Work Order ID 92475

Item Name: Crosstube Aft

DRAWING NO. D412-664-243	TITLE CROSSTUBE ASSEMBLY (412 HI AFT)	REV. E	DART AEROSPACE LTD ENGINEERING ORDER		D.E.O. NO. D412-664-243-E-1	SHEET NO. SHEET 1 OF 2	SCALE NTS
DRAWN	CHECKED	MFG. APPR.	APPROVED	DE APPR.			
DATE 11.03.31	DATE 11/03/31	DATE 11.03.31	DATE 11/03/31	DATE 11-03-31

REMOVED ABRASION STRIP IN FAVOR OF A THIN LAYER OF PROSEAL 890.

**D412-664-243
ASSEMBLY DETAIL**

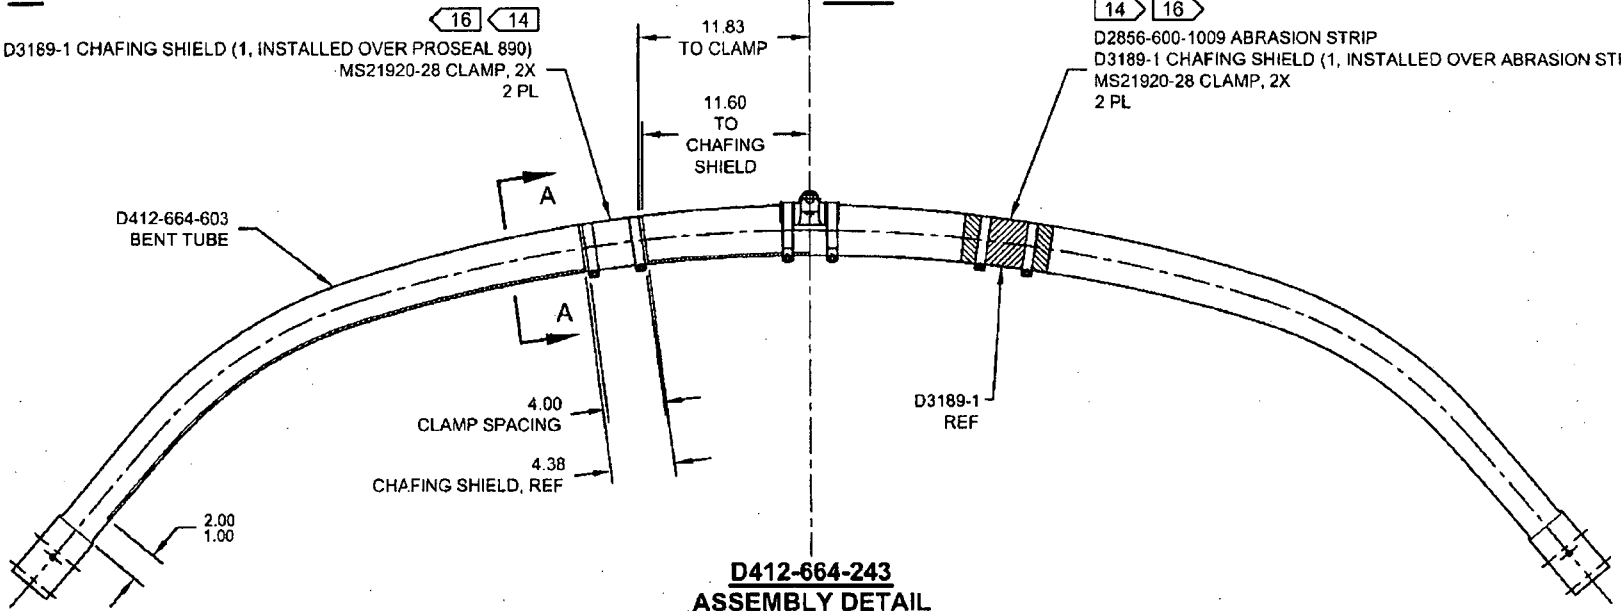
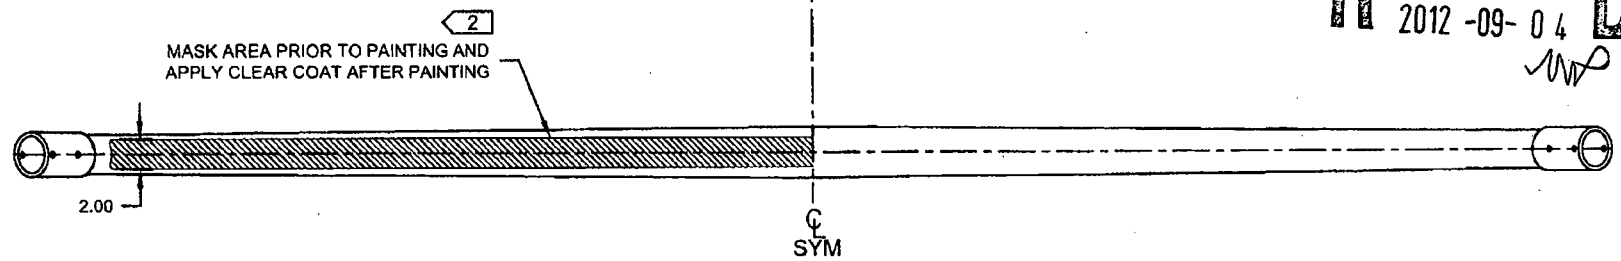
D3189-1 CHAFING SHIELD (1, INSTALLED OVER PROSEAL 890)
MS21920-28 CLAMP, 2X
2 PL

WAS:

D2856-600-1009 ABRASION STRIP
D3189-1 CHAFING SHIELD (1, INSTALLED OVER ABRASION STRIP)
MS21920-28 CLAMP, 2X
2 PL

SECTION A-A
CHAFING SHIELD DETAIL
VIEW ROTATED, NOT TO SCALE

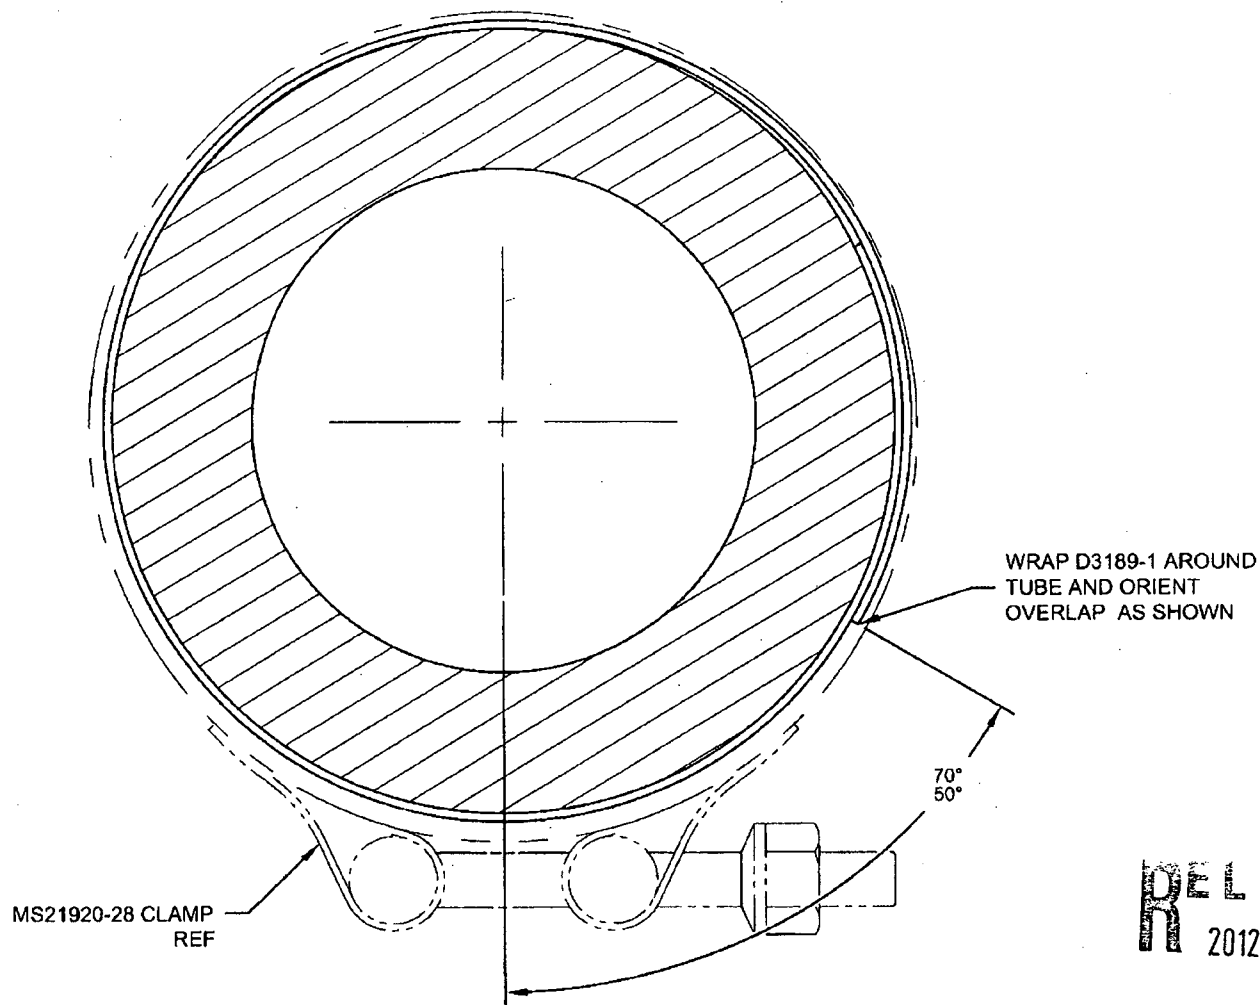
DRAWING NO. D412-664-243	TITLE CROSSTUBE ASSEMBLY (412 HI AFT)	REV. E	DART AEROSPACE LTD ENGINEERING ORDER	D.E.O. NO. D412-664-243-E-4	SHEET NO. SHEET 3 OF 3	SCALE NTS
DRAWN <i>MP</i>	CHECKED <i>MP</i>	MFG. APPR. <i>MP</i>	APPROVED <i>MP</i>	DE APPR. <i>MP</i>		
DATE 12.08.21	DATE 12.08.22	DATE 12.08.29	DATE 12.08.29	DATE 12.08.29	DATE 12.08.29
